LRN-01-0052
LCR H00-05, Sup. 1

**SUPPLEMENTAL INFORMATION FOR
REQUEST FOR LICENSE AMENDMENT
INCREASED LICENSED POWER LEVEL
HOPE CREEK GENERATING STATION
FACILITY OPERATING LICENSE NO. NPF-57
DOCKET NO. 50-354**

**HOPE CREEK GENERATING STATION
UNIT 1**

Figure 3.4.6.1-1
Hydrostatic Pressure and Leak Tests Pressure/Temperature Limits - Curve A

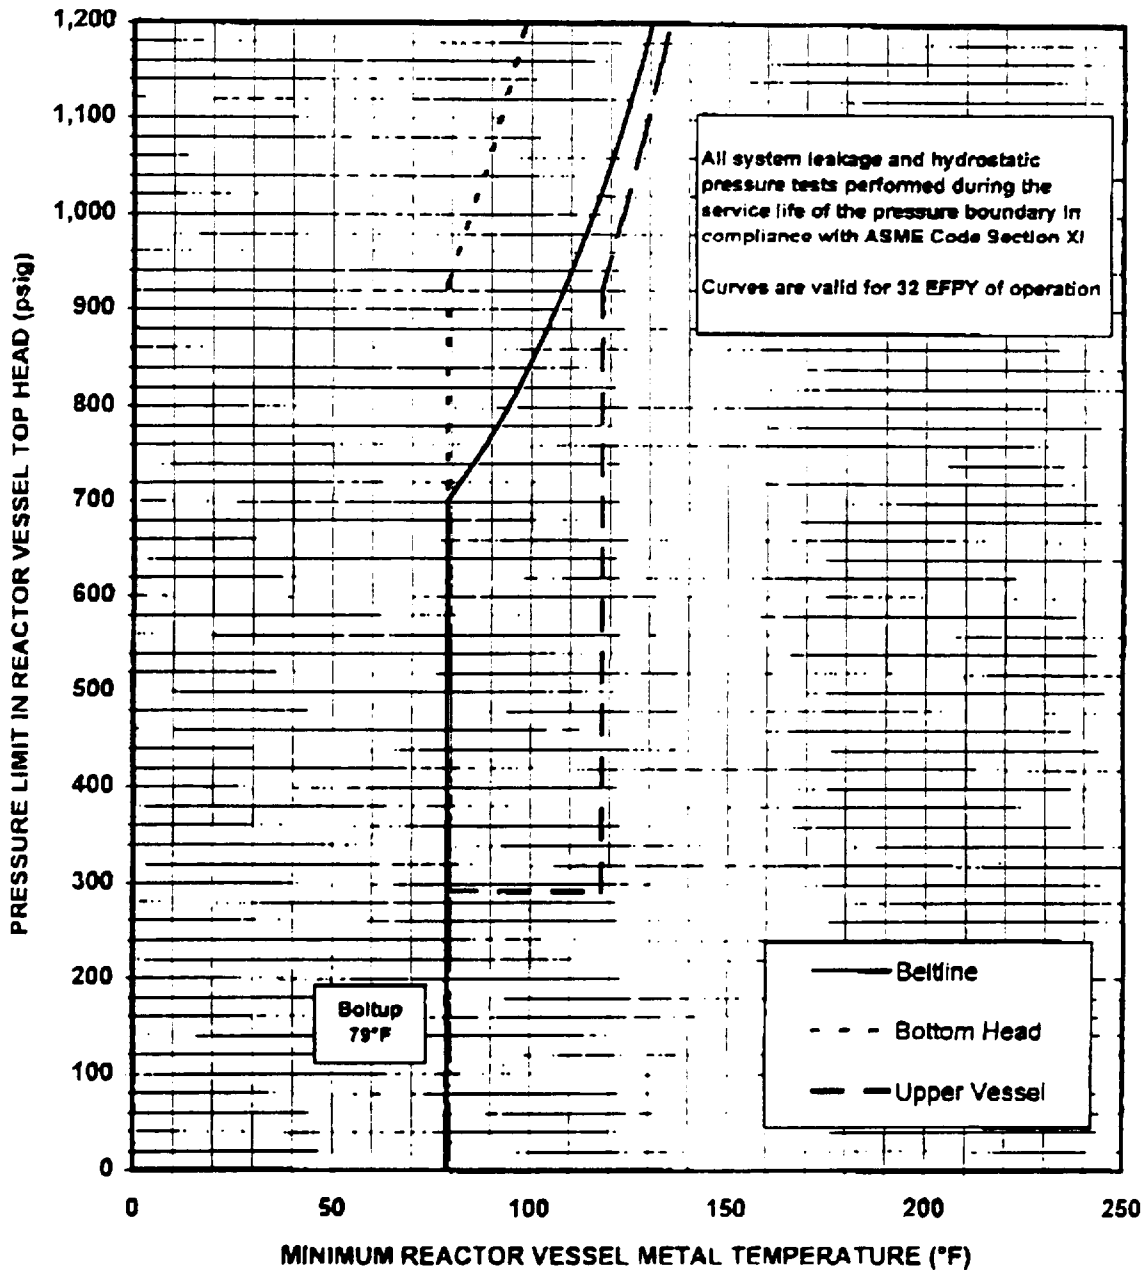
In a teleconference between members of the NRC and PSEG Nuclear on February 2, 2001, the NRC indicated that the neutron fluence used to develop the revised P-T curves did not reflect the guidance contained in Draft Regulatory Guide DG-1053, "Calculational and Dosimetry Methods for Determining Pressure Vessel Neutron Fluence," and therefore the NRC could not support approval of the new P-T limits out to 32 Effective Full Power Years (EFPY). Since there are no currently NRC approved methods that follow the guidance of DG-1053, PSEG Nuclear requests that the curves submitted on December 1, 2000 be approved for use until the end of Hope Creek Cycle 11 (currently scheduled to end in April 2003). This will allow continued operation of Hope Creek until methods are approved by the NRC that follow the guidance of DG-1053. Attachment 1 provides the revised marked-up pages of figures 3.4.6.1-1, 3.4.6.1-2, and 3.4.6.1-3 with a note that states that the new P-T curves are only valid until the end of Hope Creek Cycle 11. Please replace the revised P-T curves contained in the December 1, 2001 submittal with the P-T curves contained in Attachment 1 of this submittal.

Note: This figure is valid through Cycle 11 Operation in accordance with NRC Safety Evaluation Report supporting Amendment No. _____
